STAFF REPORT AMENDED 10-14-82
CITY PLANNING COMMISSION
915 "I" STREET - SACRAMENTO, CALIFORNIA 95814

- APPLICATION: 1. Environmental Determination
2. Variance to reduce the required 25' landscaped setback to 15' in the Light Industrial M-1(S) zone

LOCATION: 4420 Northgate Boulevard

APPLC. NO. 82-217

PROPOSED
SITE PLAN

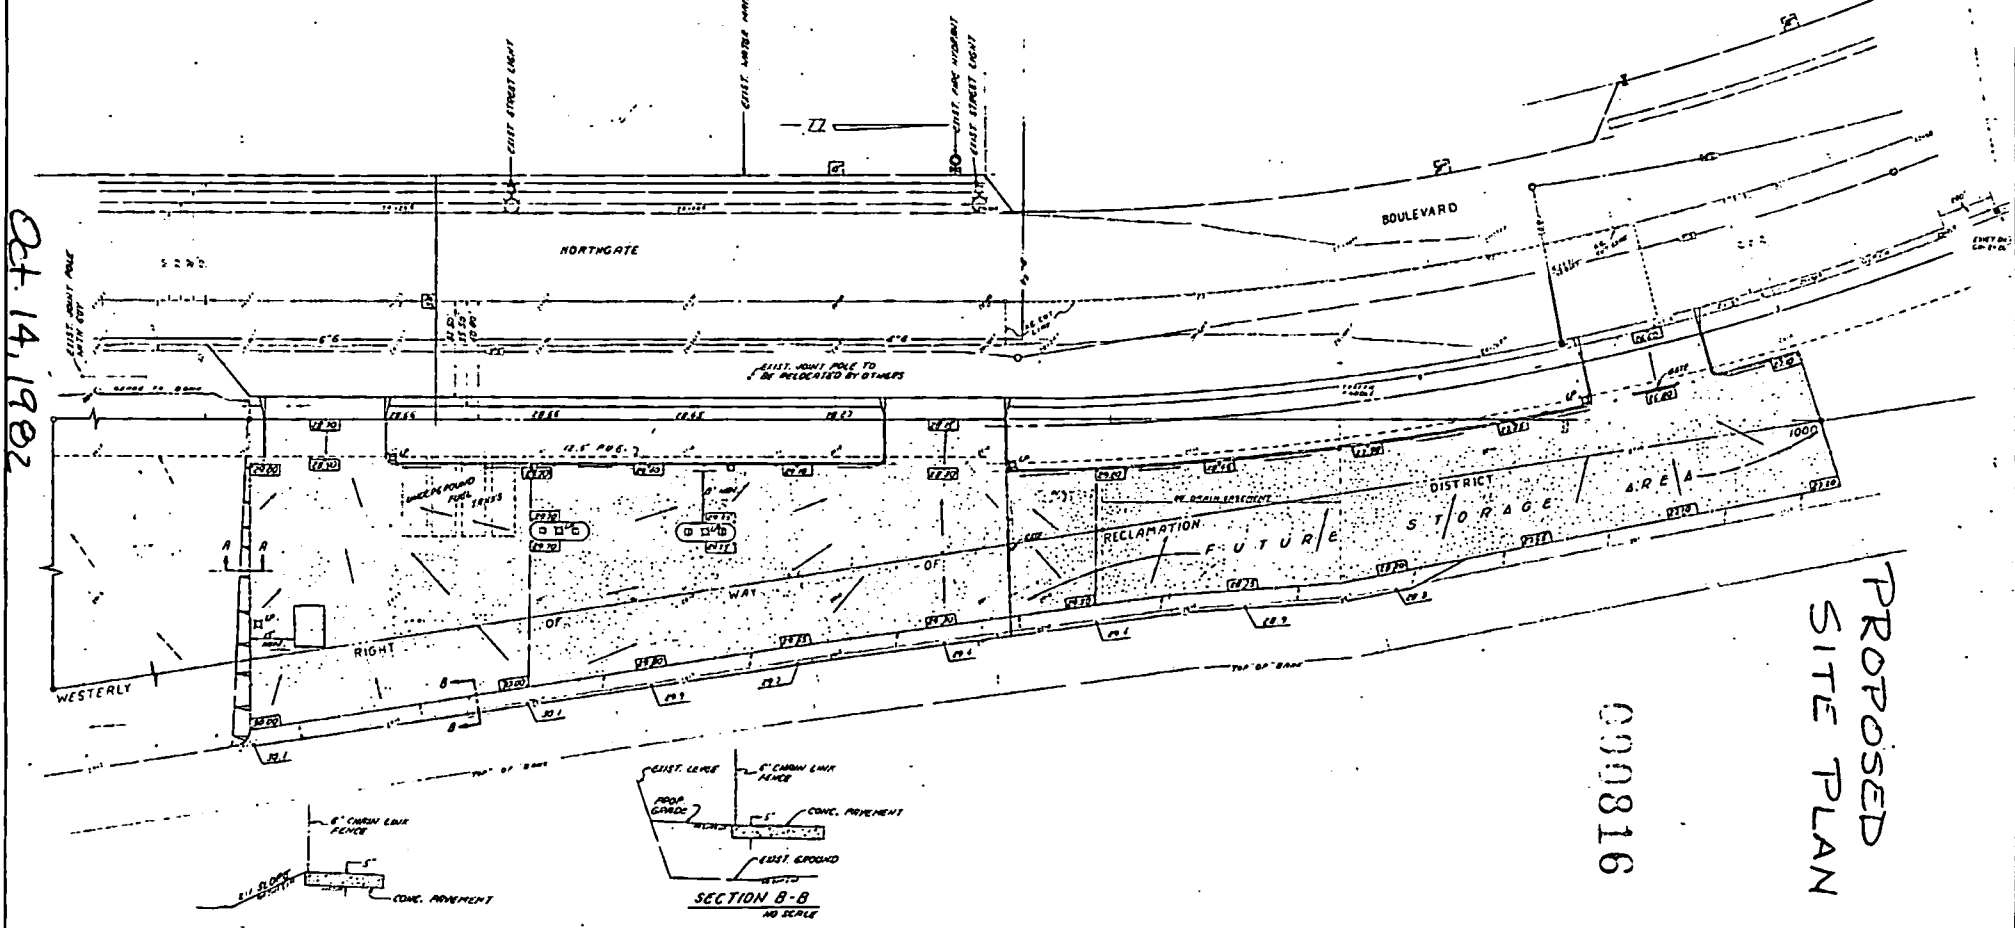
2. The applicant is requesting to reduce the required 25' landscaped setback to 15' because of the irregular shape of the parcel and the location of a 25±' wide Reclamation District easement along the eastern property line; staff supports this request. The site is shallow in depth and is difficult to develop without intruding into the front yard setback area.

3. The applicant also proposes a future storage area at the northern-most portion of the site. This area will be surfaced. All uses in the M-1(S) zone must be enclosed by a fence or wall in order to screen the activities from the public right-of-way. The applicant proposes a chain link fence around the entire site. Staff feels that a solid masonry type wall would provide a better screen along the westerly property line which is adjacent to Northgate Boulevard.

4. A six foot high masonry wall is required between residential and non-residential uses. Therefore, the applicant is required to install a 6' high wall of masonry or similar material located between the refueling area and the existing residence. This wall should not encroach in the front yard setback. Design of the walls and building materials should be approved by the Planning Director prior to issuance of building permits.

6. The project was routed to the City Traffic Engineer. Traffic suggested that any gates along entrance or driveways be set back 20' from the public right-of-way.

- *a. ~~The applicant shall erect a 6' high wall of masonry or similar material. Said wall shall be located as per exhibit B. Design and building materials shall be subject to review and approval of the Planning Director prior to issuance of building permits. (amended by CPC)~~
- b. Chain link fencing shall be located as per exhibit B and indicated on the building permit plans.
- c. Detailed landscaping and irrigation plans shall be submitted for review and approval of the Planning Director prior to issuance of building permits. One and 5 gallon shrubs and 15 gallon trees shall be used throughout the landscaped area.

- d. The applicant shall comply with the Traffic Engineer's requests that all gates be set back a minimum of 20' from the public right-of-way.

- a. Applicant shall construct appropriate visual barrier within the 15' landscaping area to buffer the proposed use from the public right-of-way. Said barrier to be worked out between the developer and staff.*
